Our Ref / Ur n-àireamh-iùil: 16/02464/FUL & 16/05382/FUL  
Your Ref / Ar n-àireamh-iùil:

Date / Ceann-là: 06 December 2016

**Planning Permission 16/02464/FUL - Installation of an Ultra Violet Treatment Plant at the Ardersier Wastewater Treatment Plant at Land 40m West of Wastewater Treatment Works, Ardersier**

**Drawing Title**  
GENERAL SITE LAYOUT  
ACCESS ROAD, SITE COMPOUND  
AND FENCING PLAN

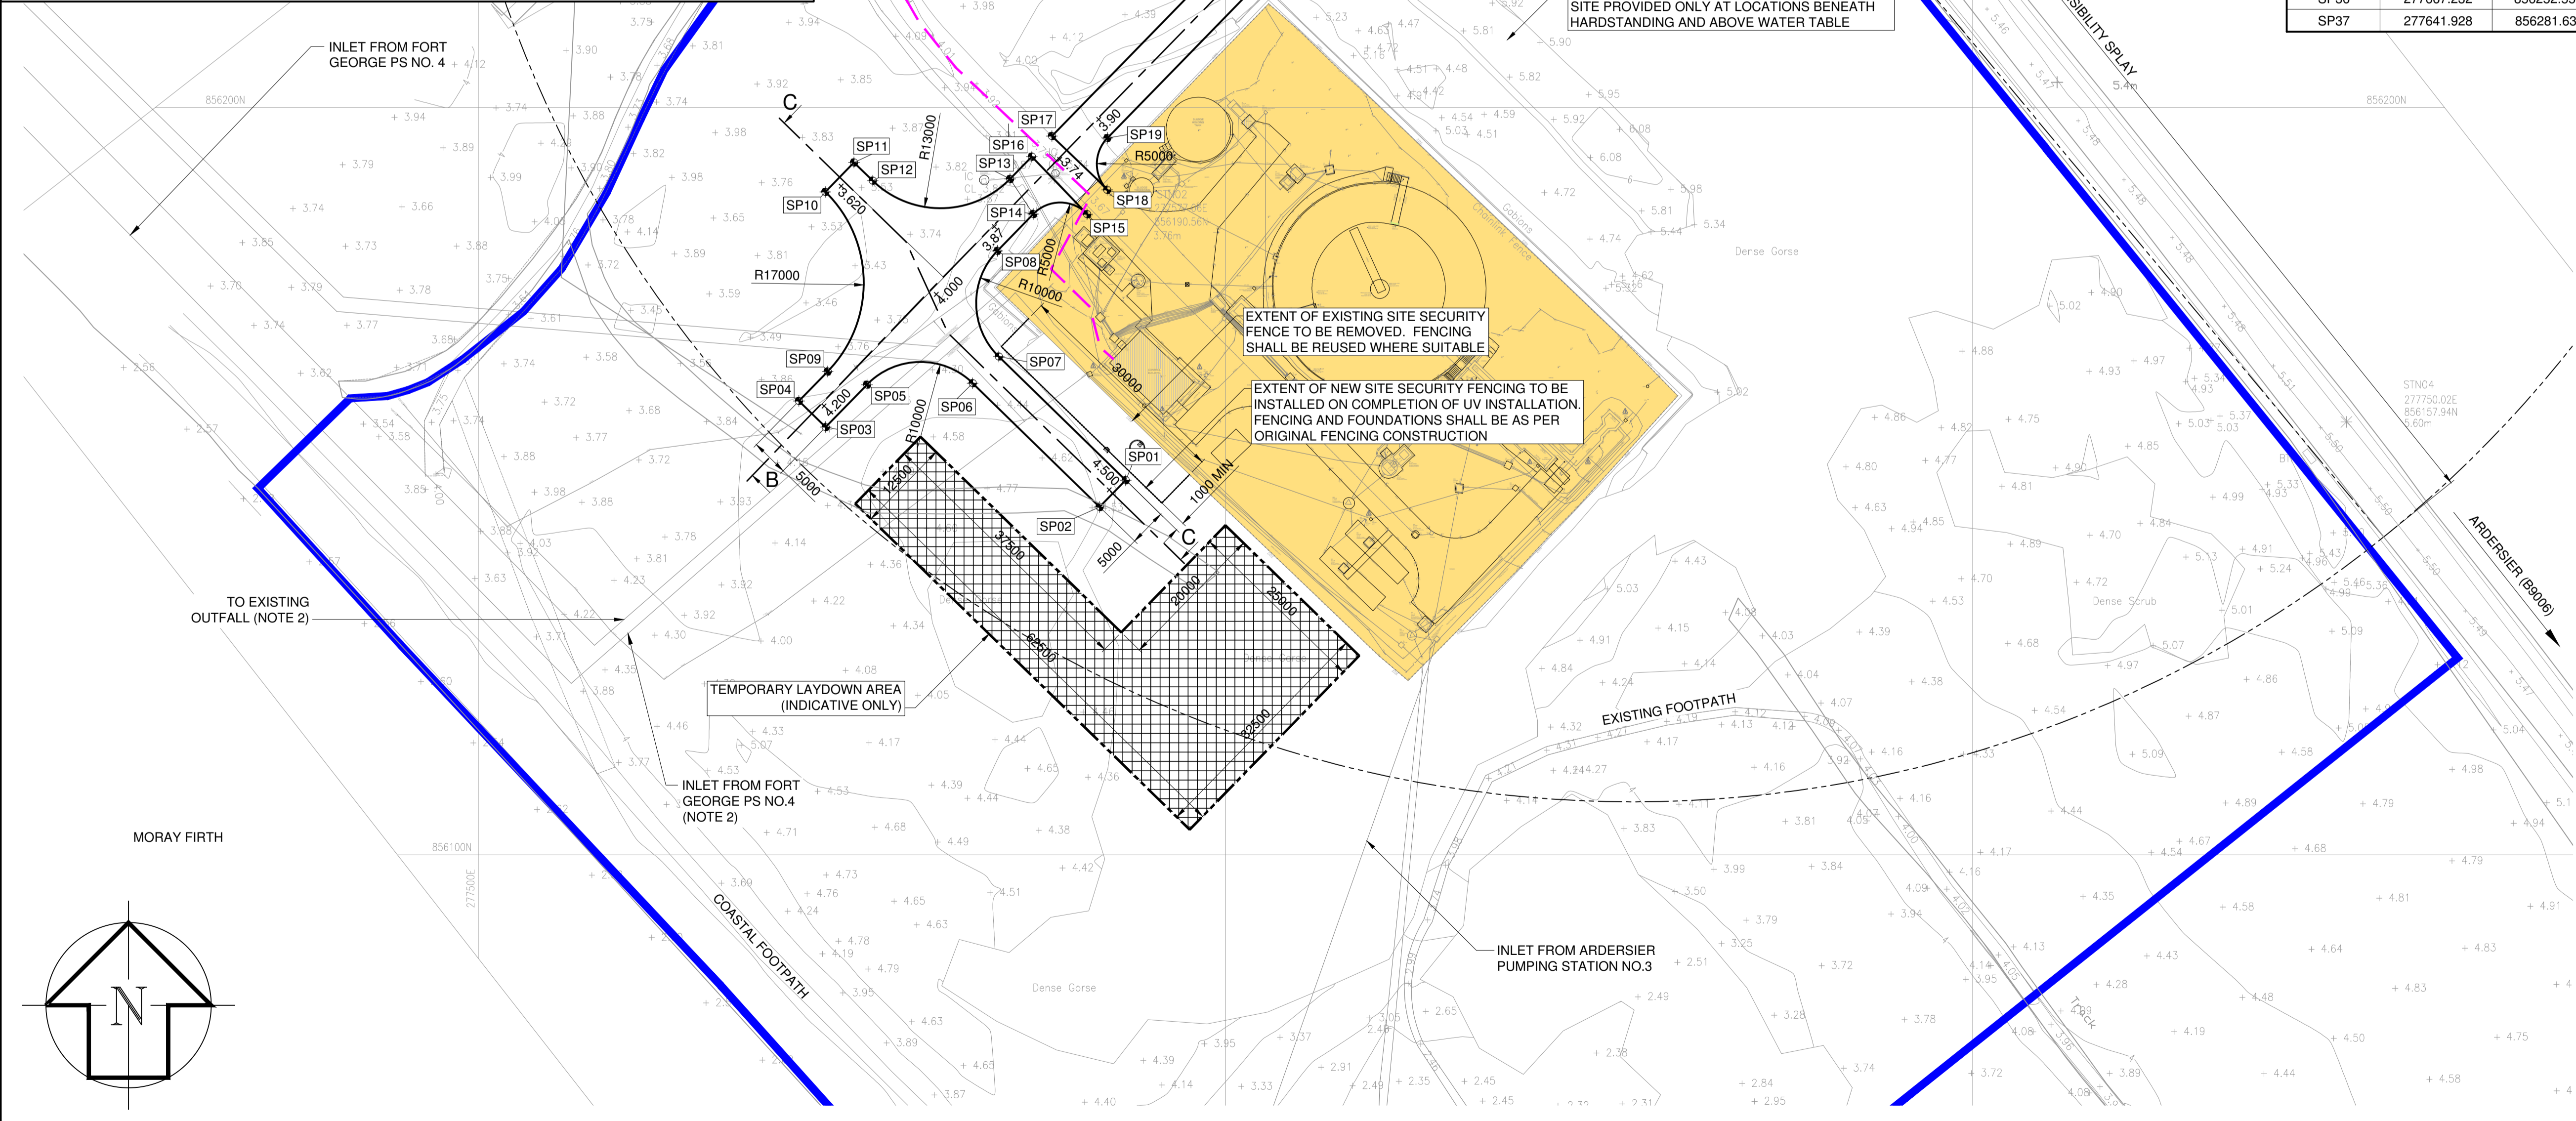
The plan is clear that post completion of the growth project, Scottish Water will use the new access road exclusively. Importantly once operational the main access into the site will be via the access approved under Planning Permission 16/02464/FUL. It is also clear that the existing access to the shore will be kept free from obstruction for existing users.

Taking the above into consideration, I am content that the submitted plan is sufficient to consider the condition satisfied. The following drawing is hereby approved and shall be implemented:

- Drawing Title: General Site Layout Access Road, Site Compound and Fencing Plan, Drawing Number 5000061980-WW-DRA-04151001-0A, Dated 21/11/16, Prepared by ESD for Scottish Water and submitted to the Planning Authority on 22 November 2016.

**SITE LAYOUT PLAN - LANDSCAPING - SECTION LOCATIONS**  
SCALE 1:500

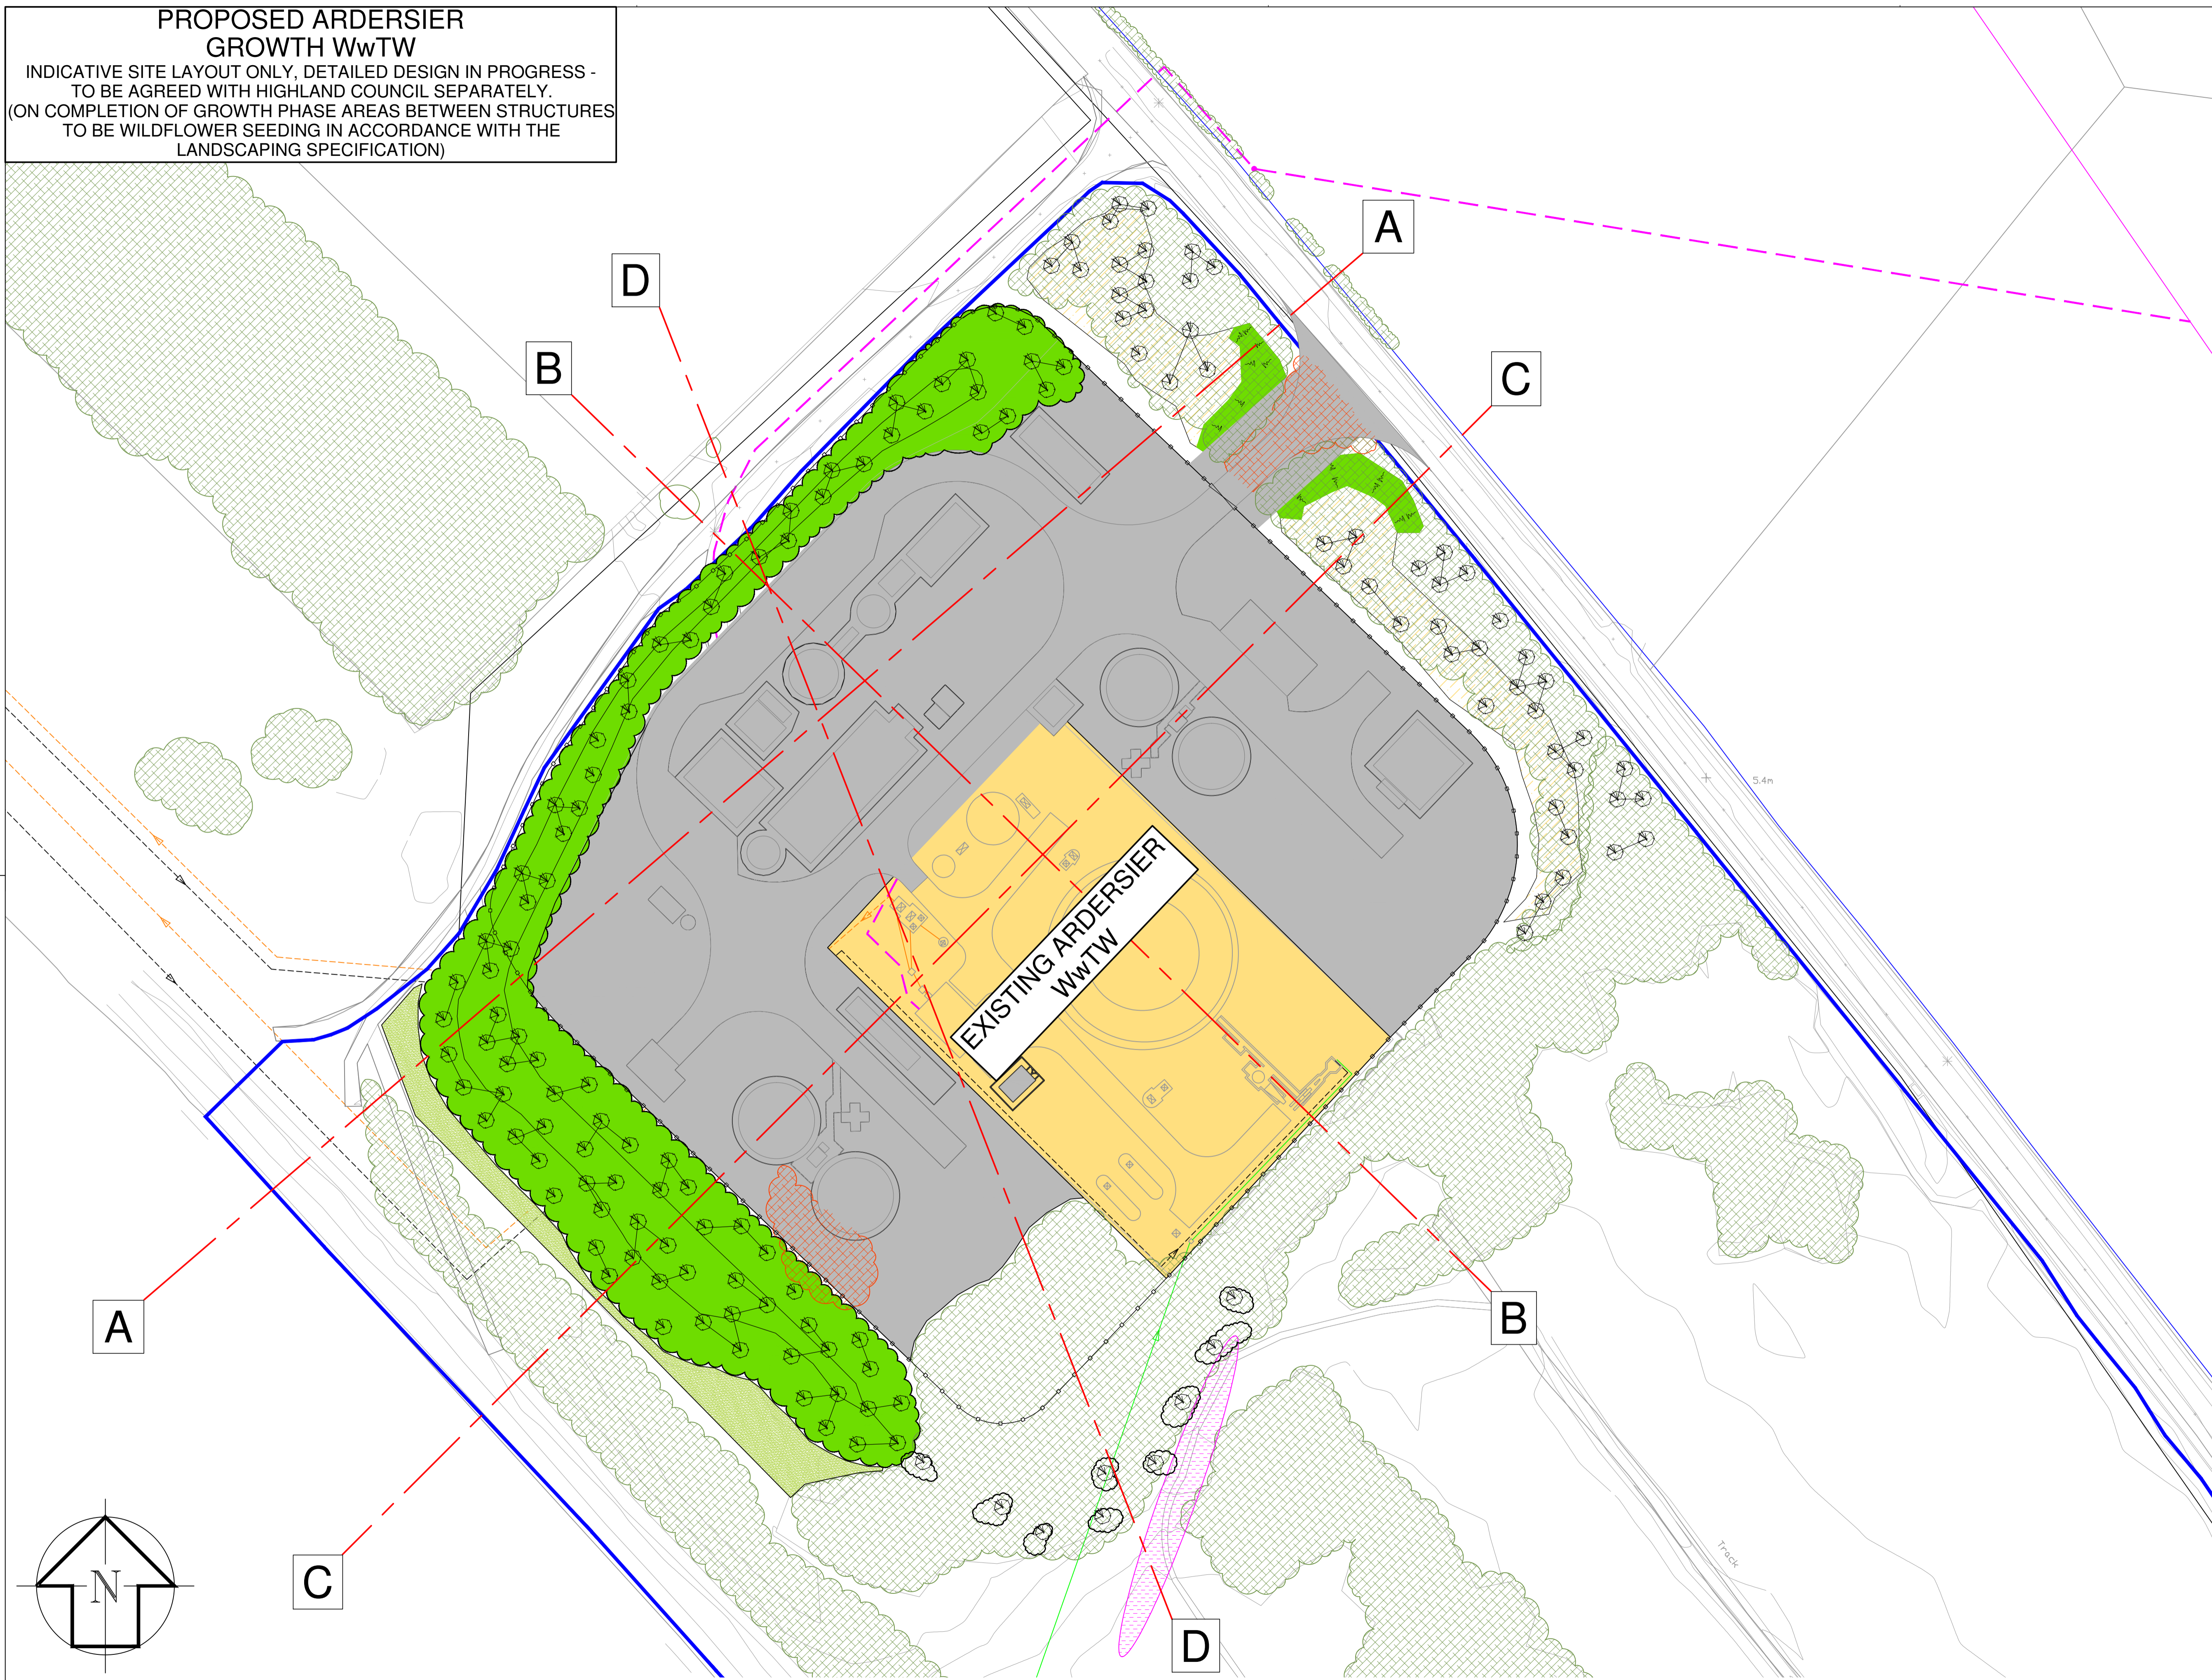
In terms of the Landscaping Plan, following the initial submission on 22 November 2016 a revised Landscaping Plan was submitted to the Planning Authority on 02 December 2016 for consideration. This addressed matters raised by the Planning Authority or those which needed modification to accord with the pre-submission advice provided by the Council's Forestry Officer. This included:

- Details of gates and fencing as per part (iv) of condition 3.
- Further details of the planting mix and some revisions to planting types to reflect the location of the development.
- A review of the sections through the site to ensure that they accorded with the revisions to the landscaping plan.
- A revision to the red-line boundary to ensure that it accorded with the red-line boundary shown on the approved planning application drawings.

Having reviewed the submitted plans and information I am content that the level of landscaping proposed and the planting mix is appropriate to the site. I am also content that the fencing proposed is sufficient. In considering whether these accord, I have considered the location of the site and the surrounding sensitivities including, but not limited to, climate, existing planting / landscaping and nature conservation. As such the following plans are hereby approved:

- Drawing Title: Site Layout Plan Landscaping - Section Locations, Drawing Number 5000061980-WW-DRA-04158002-0D, Dated 06/12/16, Prepared by ESD for Scottish Water and submitted to the Planning Authority on 06 December 2016.
